Device	XMC4700/XMC4800
Marking/Step	ES-AA, AA
Package	PG-LQFP-100/144, PG-LFBGA-196

Document ID is **056/18**.

This “Errata Sheet” describes product deviations with respect to the user documentation listed below.

Figure 1 Influence of concurrent conversions on reference voltage

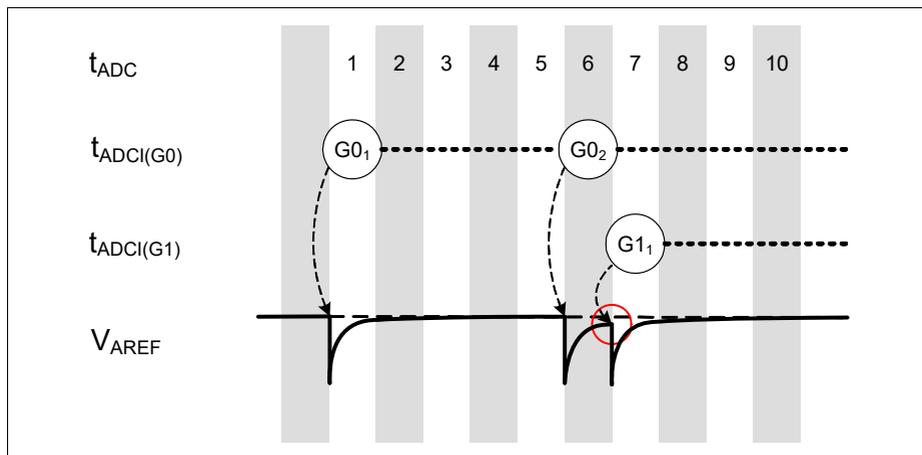
ADC_CM.001 Conversion results can be wrong if groups are not synchronized

Due to this architecture, the individual prescalers may be displaced by one module clock as shown in the figure below for G0₂ and G1₁. In this example the division factor is 5 (DIVA=4).

In cycle 1 only the G0 conversion step is started. At start time the reference voltage is strobed and a certain amount of electric charge (see data sheet parameter Q_{CONV}) is consumed. This causes a drop of the reference voltage level V_{REF} . Quantity of voltage drop depends on analog voltage level to convert.

In cycle 6 another G0 conversion step is starting and in cycle 7 a G1 conversion step. In this case the reference voltage may not yet be fully recovered when the G1 conversion step strobes V_{REF} . Consequently, the G1 conversion step yields an incorrect value.

In repeated measurements using the example setup errors up to 25 LSB have been observed in 10-16 of 4096 conversions. Magnitude of the error however depends on the system configuration and load. The workaround therefore should be applied for all applications.

If two or more converter groups (G0-G3) are started (initialized) asynchronously and multiple conversion steps or sample phases occur in the same time frame then the reference voltage settling time can be violated, which leads to incorrect conversion results.

The workaround makes sure that all ADC group clocks $f_{\text{ADC}(Gx)}$ are started concurrently. Even if your application does not require a master/slave configuration this sequence ensures a synchronized start behaviour.

1. Disable all ADC groups (x=0-3) by clearing ASEN_y (y=0-2)
bits: G_xARBPR.ASEN_y = 0
2. Configure the queue, scan and background sources as required.
3. Configure one group as master, others as slaves and set EVALR_y (y=1-3):
G_xSYNCTR.EVALR_y = 1 G0SYNCTR.STSEL = 00 -- G0 is master
0 G1SYNCTR.STSEL = 01 -- G1 is slave of master 0
G2SYNCTR.STSEL = 01 -- G2 is slave of master 0
G3SYNCTR.STSEL = 01 -- G3 is slave of master 0
4. Configure the slave groups G1, G2, G3
G_xARBCFG.ANONC = 00 -- Converter off
-- Remaining G_xARBCFG bits are set as required
5. Configure the master G0
G0ARBCFG.ANONC = 11 -- Converter on
-- Remaining G_xARBCFG bits are set as required

Figure 2 Parity Checker diagram

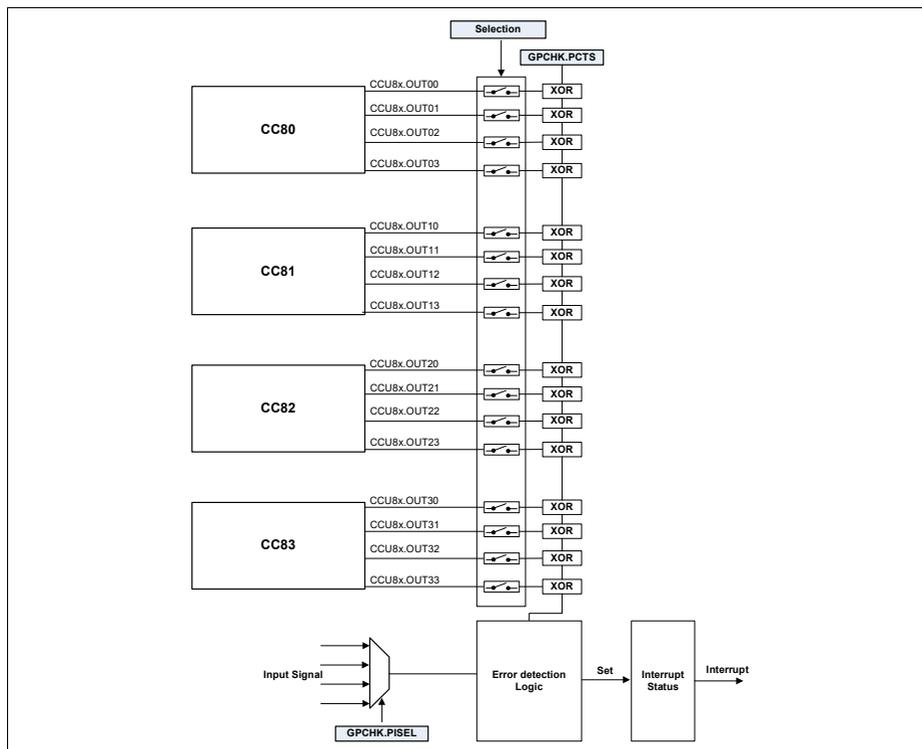
CCU8_AI.003 CCU8 Parity Checker Interrupt Status is cleared automatically by hardware

When using the parity checker function, the associated status bitfield, is cleared automatically by hardware in the next PWM cycle whenever an error is not present.

This means that if in the previous PWM cycle an error was detected and one interrupt was triggered, the software needs to read back the status register before the end of the immediately next PWM cycle.

Not ORing the Parity Checker error interrupt with any other interrupt source. With this approach, the software does not need to read back the status information to understand what was the origin of the interrupt - because there is only one source.

Figure 3 CCU8x concatenation feature resource configuration - a) without external count function; b) with external count function

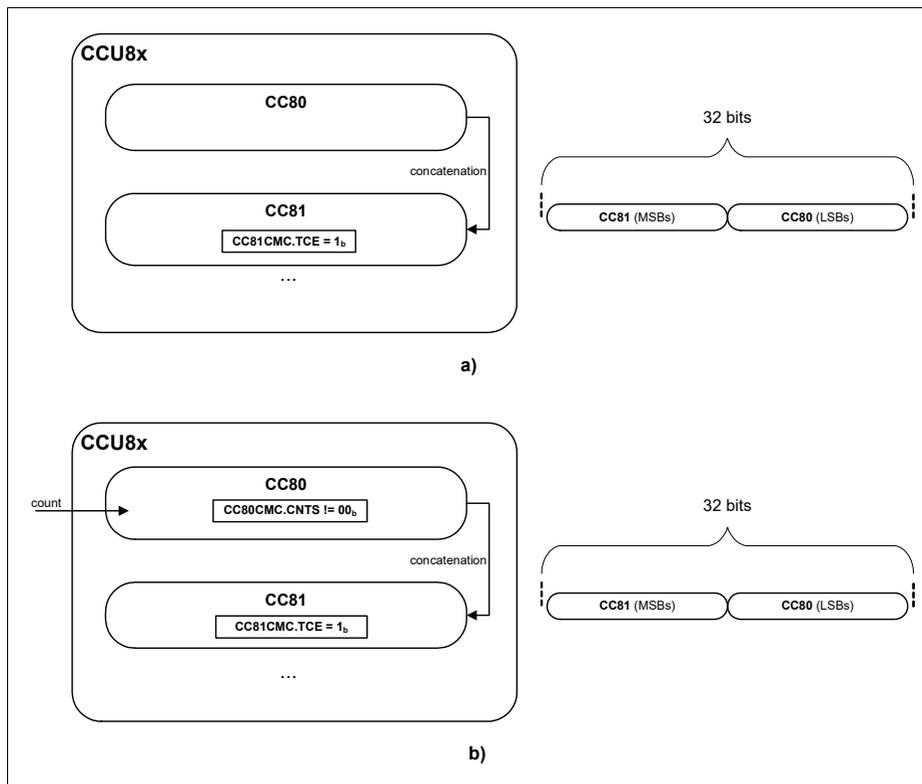
CCU8 AI.006 Timer concatenation does not work when using external count signal

When an external count signal is enabled - by programming the CC8yCMC.CNTS with 01_B , 10_B or 11_B - the concatenation function does not work. One cannot use in parallel the timer concatenation and external count signal features.

None

Figure 4 Clock Selection Diagram for CCU4

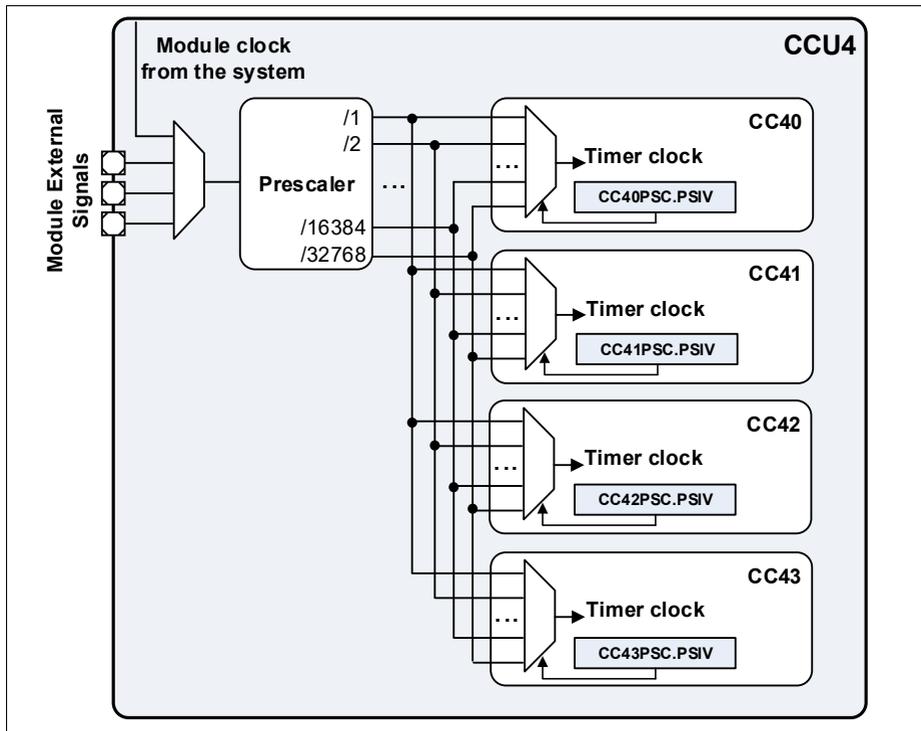
CCU_AI.005 CCU4 External IP clock Usage

Currently is only possible to use an external signal as Timer Clock when a division ratio of 2 or higher is selected. When no division is selected (divided by 1), the external signal cannot be used.

The user must program the PSIV field of each Timer Slice with a value different from 0000_B - minimum division value is /2.

None.

Figure 5 PADT update behavior

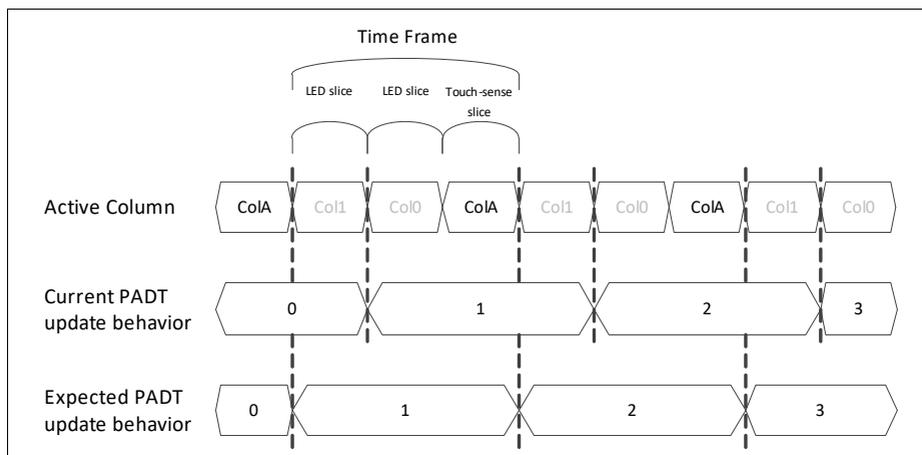
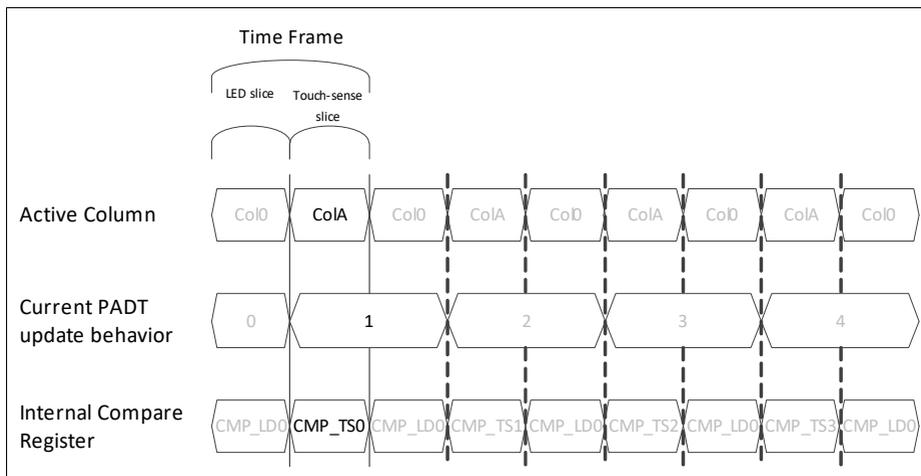
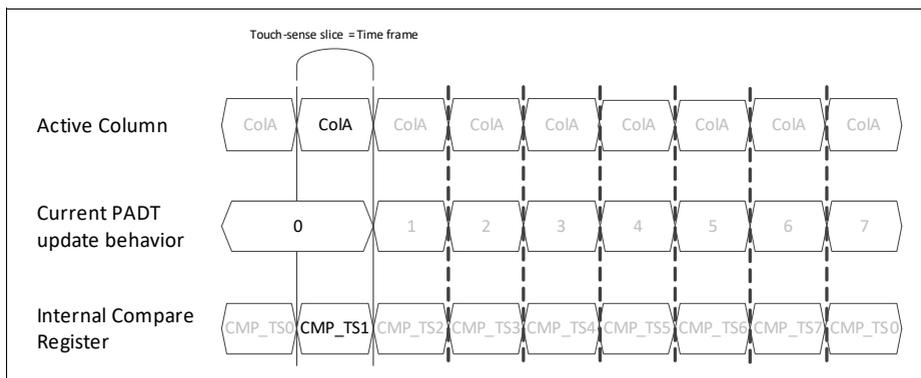
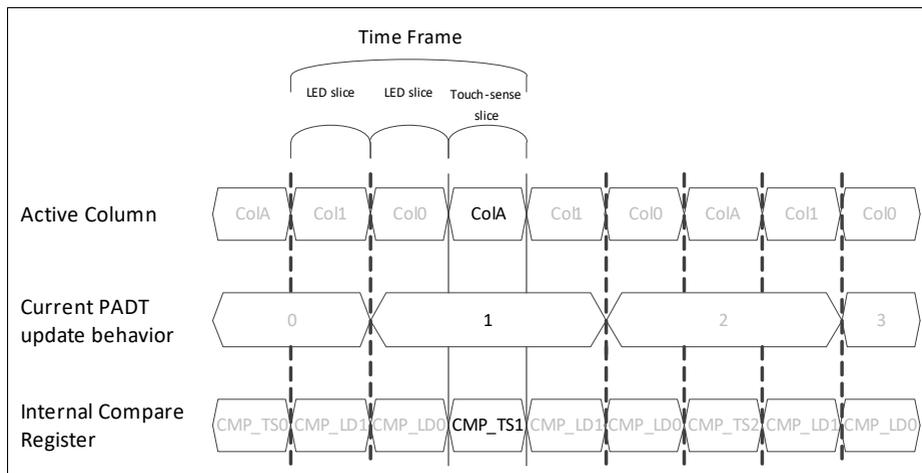
LEDTS_AI.001 Delay in the update of FNCTL.PADT bit field

The touch-sense pad turn (PADT) value is updated, not at the end of the touch-sense time slice (ColA), but one time slice later (**Figure 5**).

If the number of LED columns enabled is smaller than 2, the delay will affect the activation period of the current active pad. At the beginning of every new Col A, the value of the current PADT's compare register is updated to the internal compare register. However, the delay causes the value of the previous PADT's compare register is updated to the internal compare register instead. This means that the current active pad would be activated with the duration of the previous pad's oscillation window (**Figure 6**). In addition to this, when no LEDs are enabled, pad turn 0 will prevail for one time slice longer before it gets updated (**Figure 7**).

If the number of LED columns enabled is 2 or more, the additional LED columns would provide some buffer time for the delay. So, at the start of a new touch-sense time slice, the update of PADT value would have taken place. Hence, the current active PADT compare register value is updated to the internal compare register (**Figure 8**).

Figure 9 Software workaround demonstration

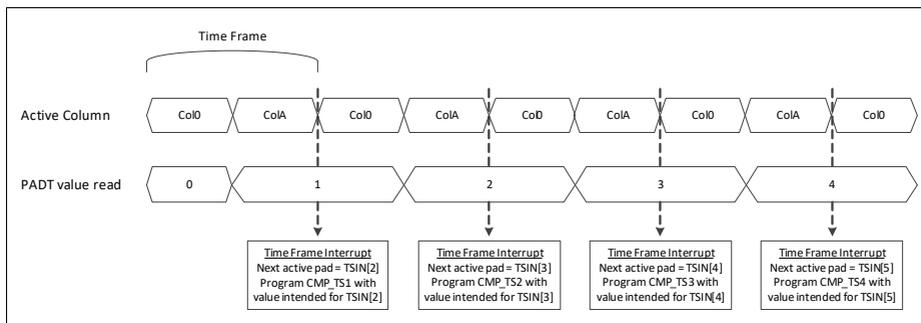
However, it is still possible to work around this issue when using the hardware pad turn control. In the previous section, it is known that when the number of LED columns enabled is smaller than 2, the current active pad is activated with the oscillation window of the previous active pad. This means that the current active pad is activated with the value programmed in the bit field CMP_TS[x-1] instead of CMP_TS[x]. There are two possible software workarounds for this issue:

1. At the end of the time frame interrupt service routine, software can prepare for the next active pad turn by programming the CMP_TS[x-1] bit field with the intended compare value for TSIN[x]. As an example, if the next active pad is TSIN[2], program CMP_TS[1] with the compare value intended for TSIN[2] (**Figure 9**).

1. During the initialization phase, program the CMP_TS[x] bit fields with the left-shift factored in. Example: CMP_TS[0] for TSIN[1], CMP_TS[1] for TSIN[2], ... CMP[7] for TSIN[0].

Figure 11 Different index signal types

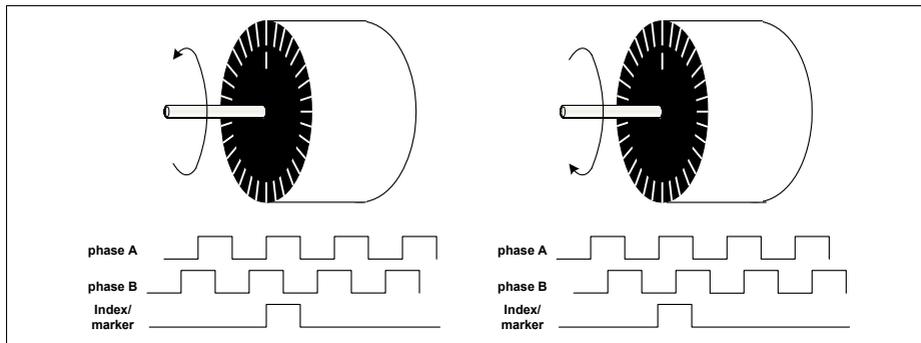
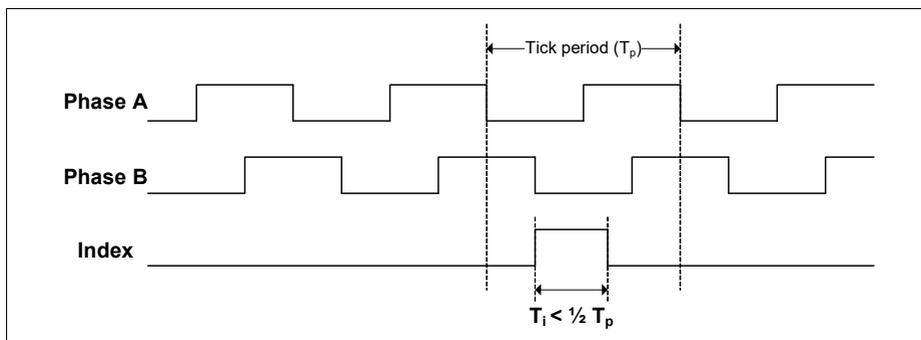
POSIF_AI.001 Input Index signal from Rotary Encoder is not decoded when the length is 1/4 of the tick period

When the index signal is smaller than 1/2 of the tick period, the POSIF module is not able to decode this signal properly, Figure 2 - notice that the reference edge of the index generation in this figure is the falling of Phase B, nevertheless this is an example and depending on the encoder type, this edge may be one of the other three.

Due to this fact it is not possible to use the POSIF to decode these type of signals (index with duration below 1/2 of the tick period).

Figure 15 ABM/PSRAM Header - Location of reserved bytes

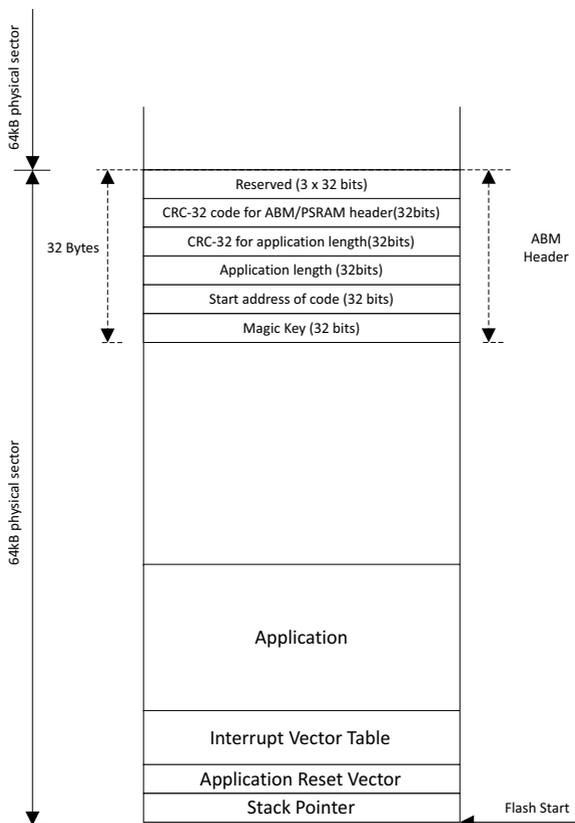
The reference manual is specifying PSRAM/ABM Header of 32 byte size. Only for 20byte of these 32 bytes the functionality is defined. The remaining 12bytes are reserved. Inside the chapter for Startup modes of the reference manual only the functional bytes are specified but not the location of the reserved bytes.

The following figure provides a detailed view on the location of the reserved bytes:
